Product Change Notification / ASER-11ZWRV458

CCB 5295 Final Notice: Qualification of MTAI as a new final test site for selected AT17LVxxx device family available in 8L PDIP (.300in) package.

Description of Change:Qualification of MTAI as a new final test site for selected AT17LVxxx device family available in 8L PDIP (.300in) package.

Tube Comparison – BQM and Pin 1 Orientation

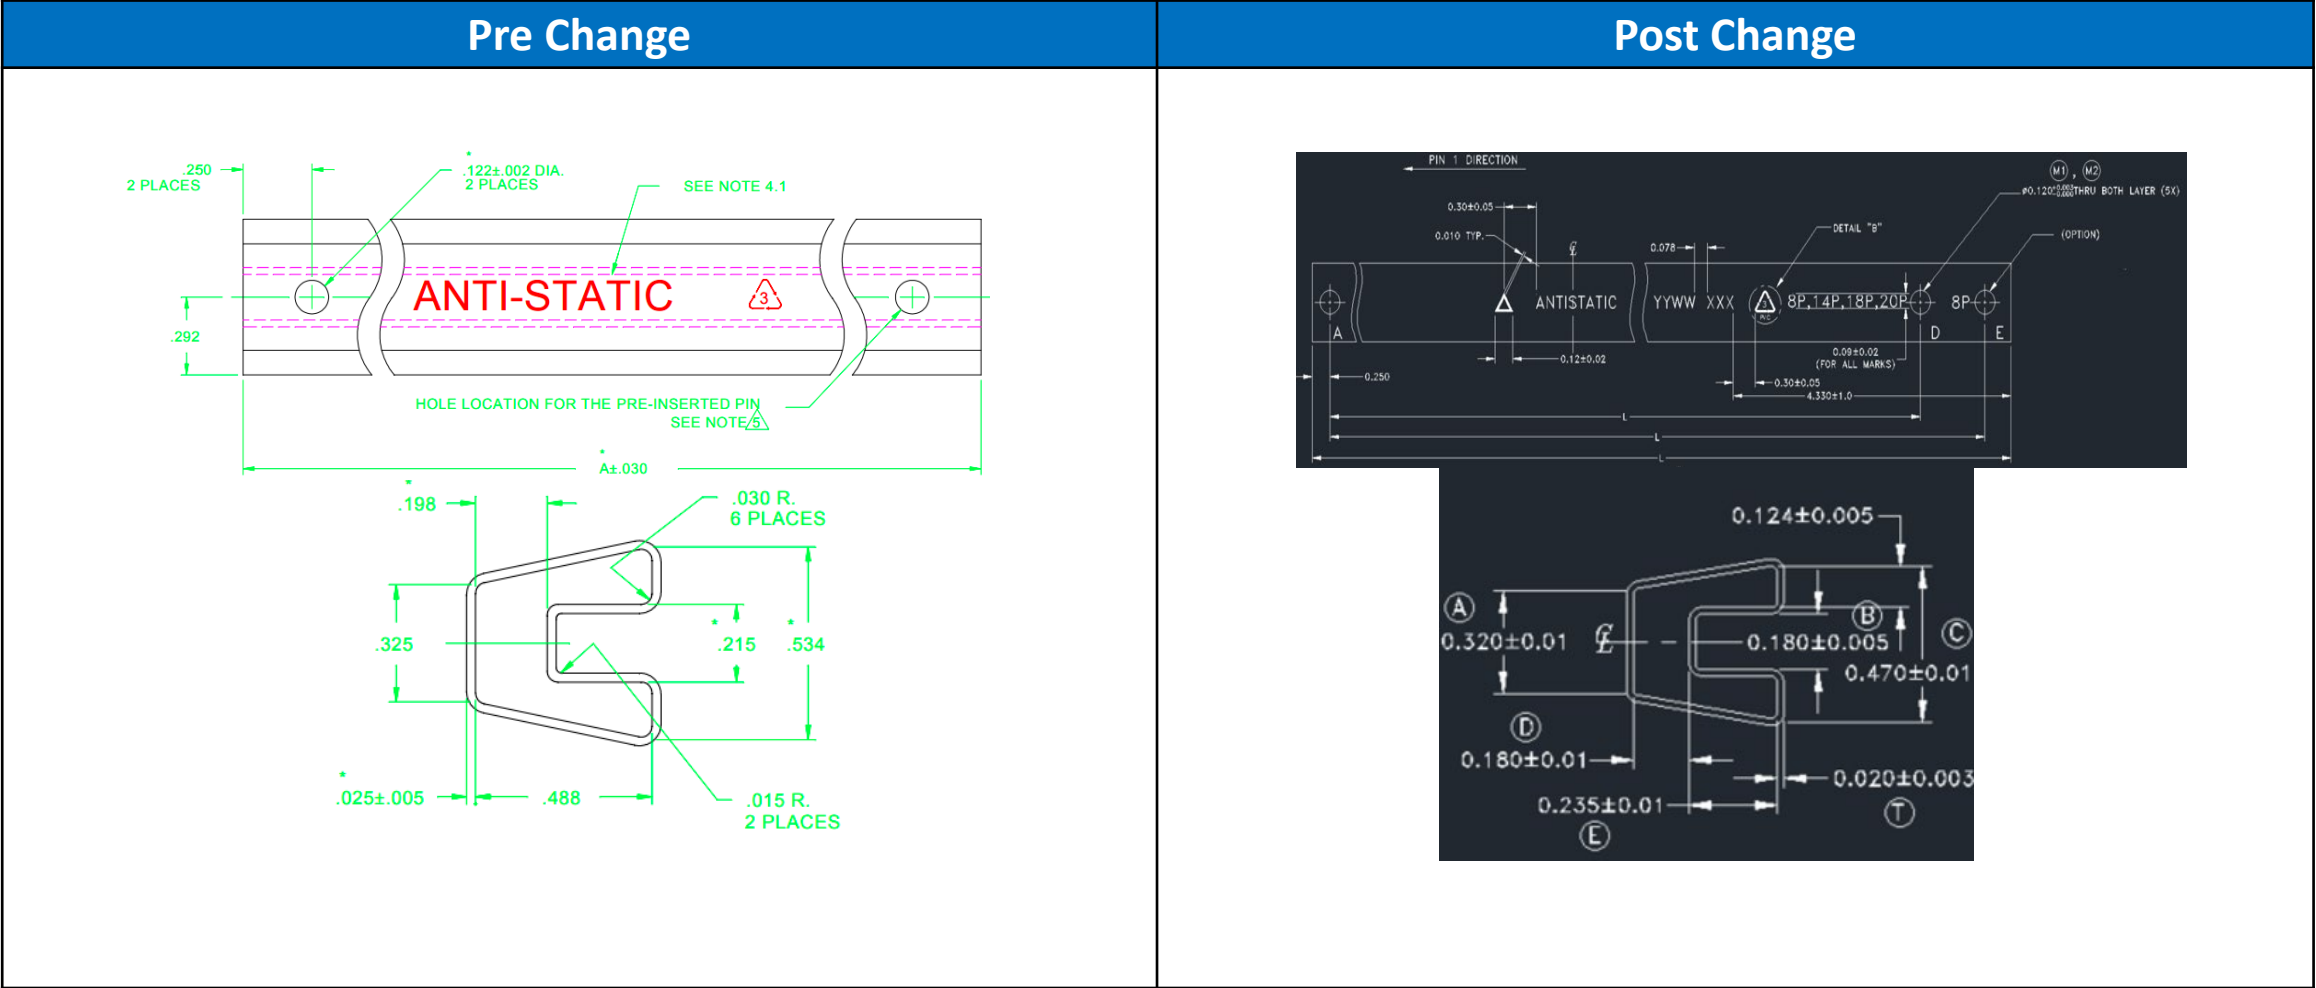
Pre Change

Media	Pin1 Side
TUBE	
	Black Pin White Pin

Media	Unit per Tube	Tube per Bag	Unit per Bag	Pin#1 Orientation
TUBE	50	50	2500	Toward White Pin

Post Change

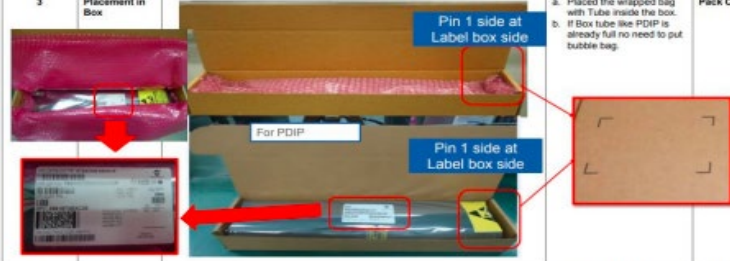
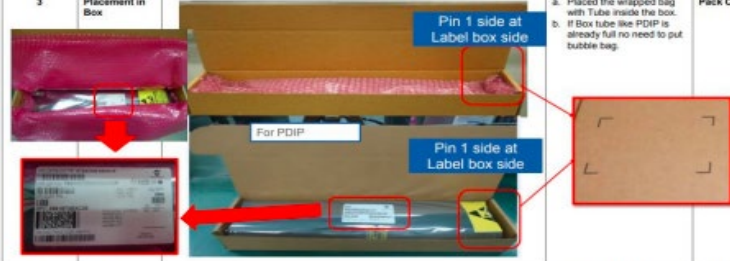
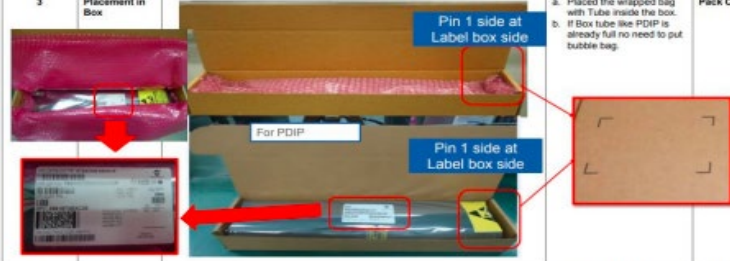
Media	Pin1 Side
TUBE	
	Black Pin White Pin

Media	Unit per Tube	Tube per Bag	Unit per Bag	Pin#1 Orientation
TUBE	50	40	2000	Toward White Pin
